SMARTCODE BUILDING/SITE PLAN APPLICATION (ARTICLE 5)

2. Description of Project: 71-unit apartment building with underground parking

Lot 5 North Park Article 5 Conditions:

We have reviewed city staff comments. Please see our responses in red below and contact Jim Beltran with any questions.

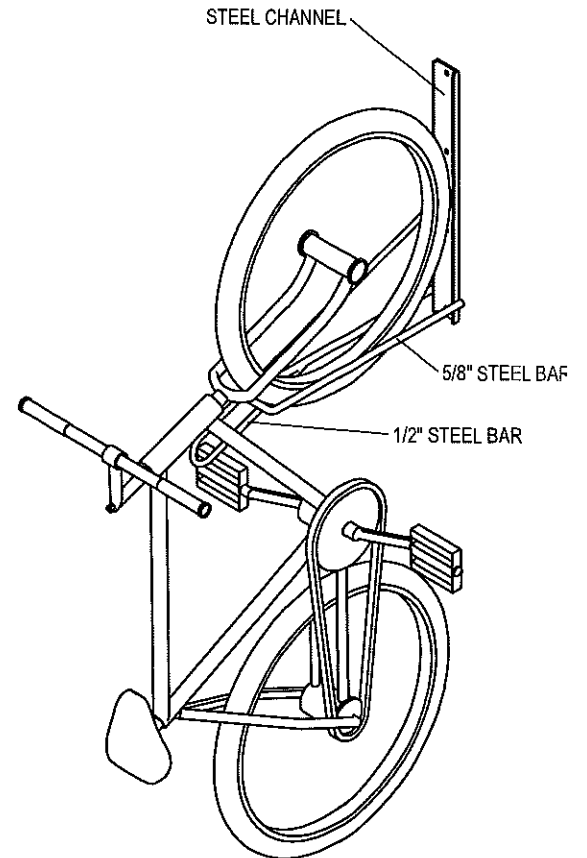
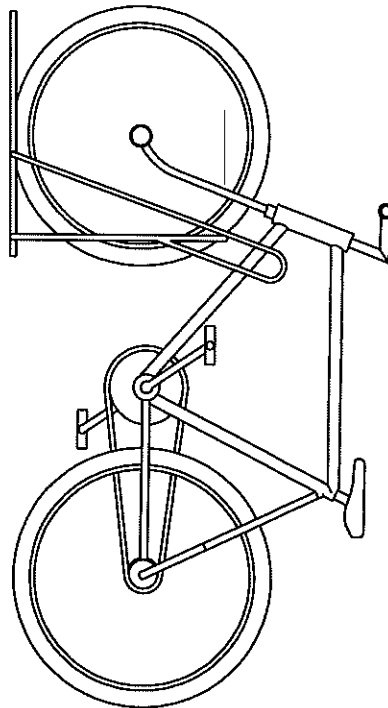
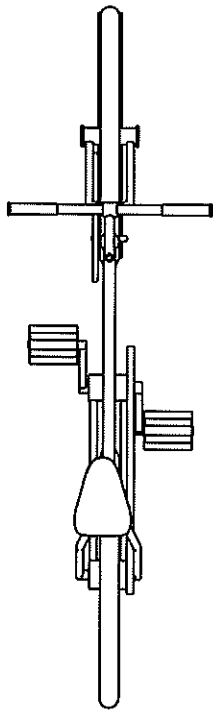
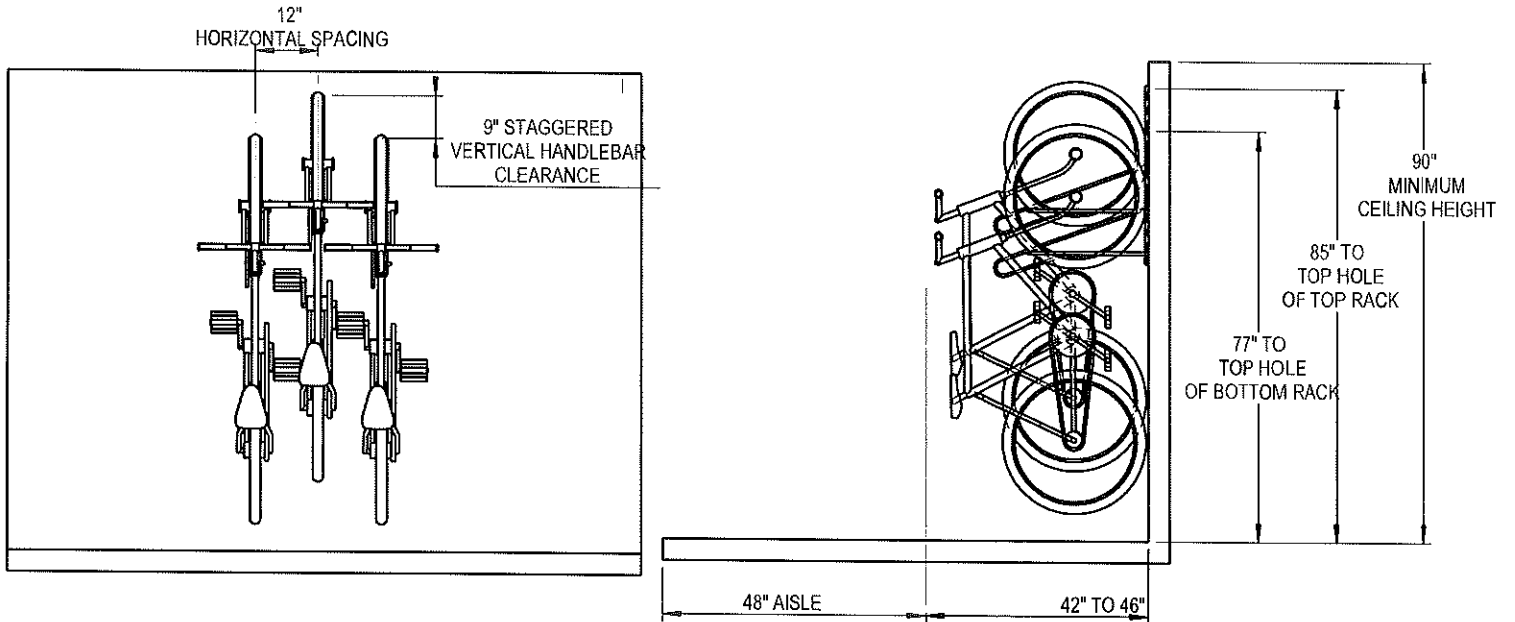
This is a request for an Administrative Waiver to allow the use of a hedge streetscreen for the non-parking areas on a 71-unit apartment building in the development located at the southwest corner of Lacy Road and Syene Road. The owner would like to pursue Section 5.7.5 (f) with the intent of adding interest with plantings instead of standard fencing materials.

Street screening at parking areas will remain per Smartcode requirements as shown on the submitted drawings.

6 BIKE PARKING DETAIL

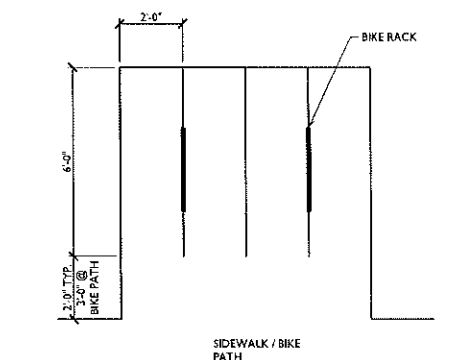
2. The bike parking areas that are located adjacent to public sidewalk shall provide a minimum 2-ft clear zone between the edge of the sidewalk and a parked bicycle. To maintain this clearance, bike racks that are perpendicular to the sidewalk should be mounted no closer than 4' to the edge of the sidewalk. **See detail 6 / C-1.1.**

3. The bike parking areas that are located adjacent to the bike path shall provide a minimum 3-ft clear zone between the edge of the path and a parked bicycle. To maintain this clearance, bike racks that

are perpendicular to the path should be mounted no closer than 5' to the edge of the path. **See detail 6 / C-1.1.**

BUILDING #3 SITE PLAN
SCALE: 1:20

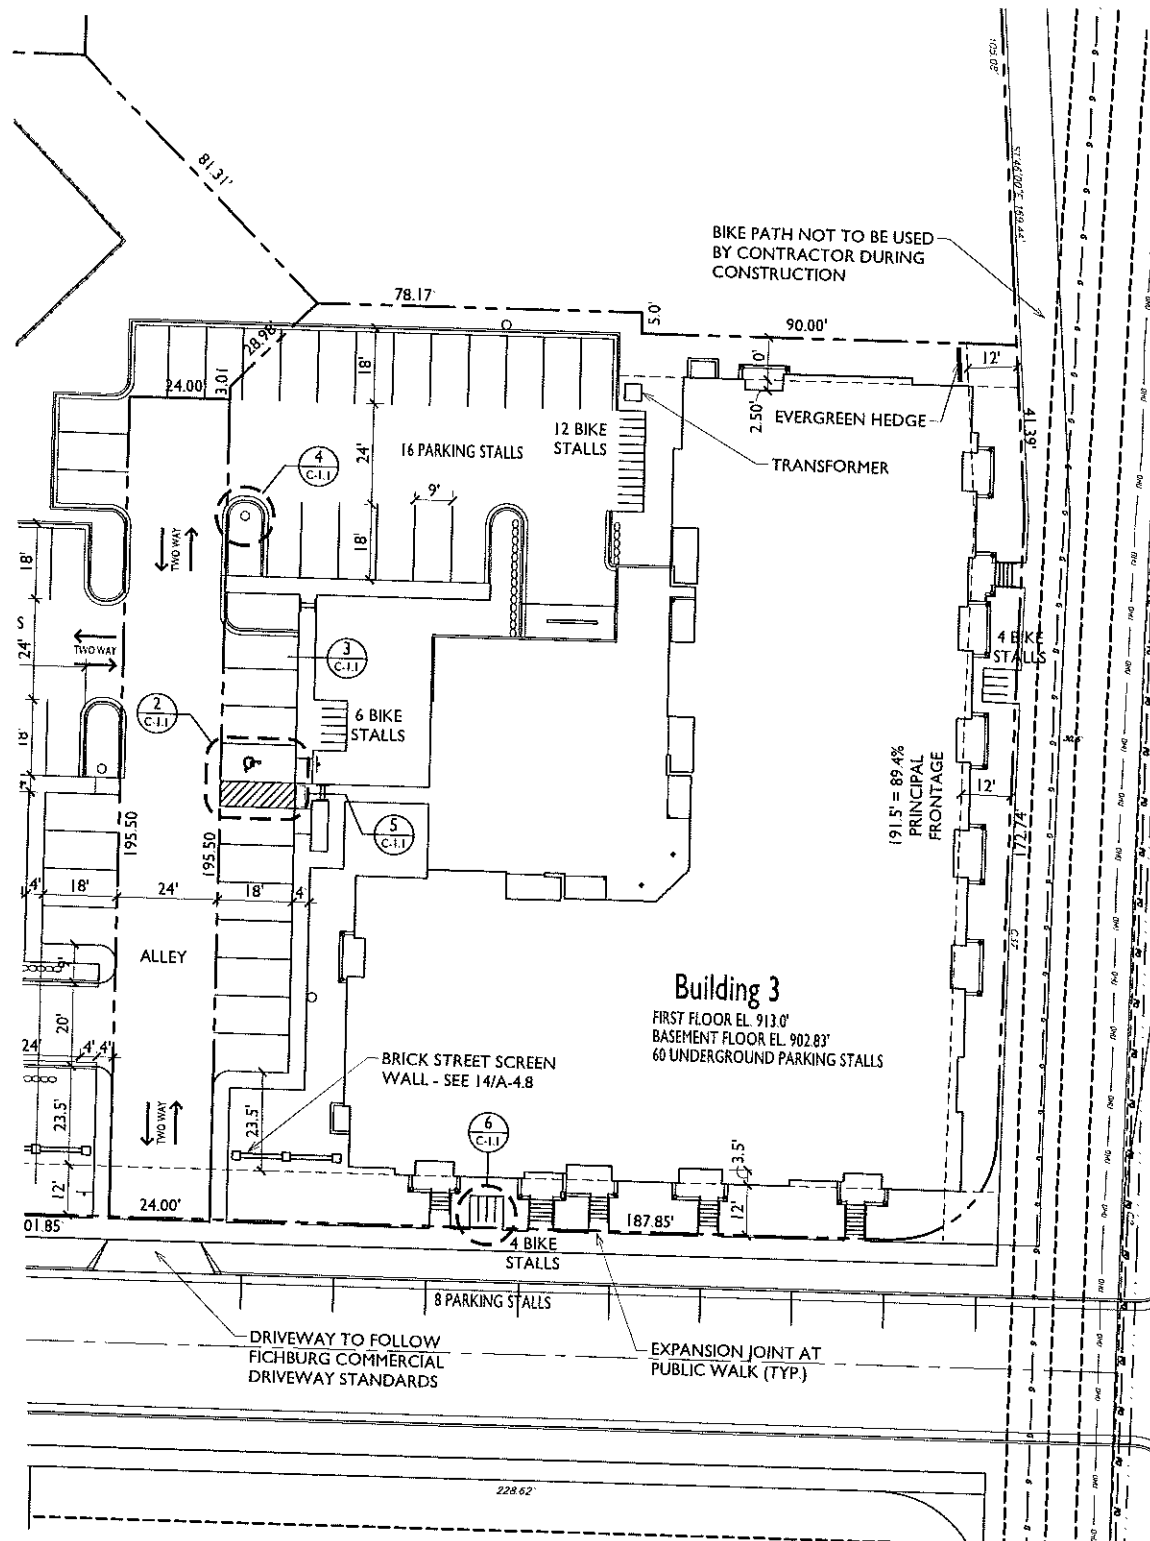
- 3.) Please better distinguish the property line on plan sheet C-1.1 as it's a bit hard to identify. **Line weight has been adjusted.**
- 4.) An Administrative Approval is needed for:

4. Sidewalk adjacent to Lot 3 shall be installed per the First Amendment to the Agreement for Subdivision Improvements in the Plat of North Park (Documents #5116733). **Will comply.**
5. Label expansion joint between private stairs and public sidewalk. **Requirement has been added to C-1.1.**
6. The City is still deciding on a pedestrian-scale street light which will be located in the terrace area between the sidewalk and the curb and gutter. It is likely that at least one new street light, possibly 2, will be required along Aurora Ave. within the limits of the street frontage for Building 3. **Understood.**
7. The bike path along Lacy Road shall remain open during construction and shall not be used by the building contractor. Any damages to the path, caused by the building construction, shall be repaired prior to occupancy. **Understood. This has been noted on C-1.1.**
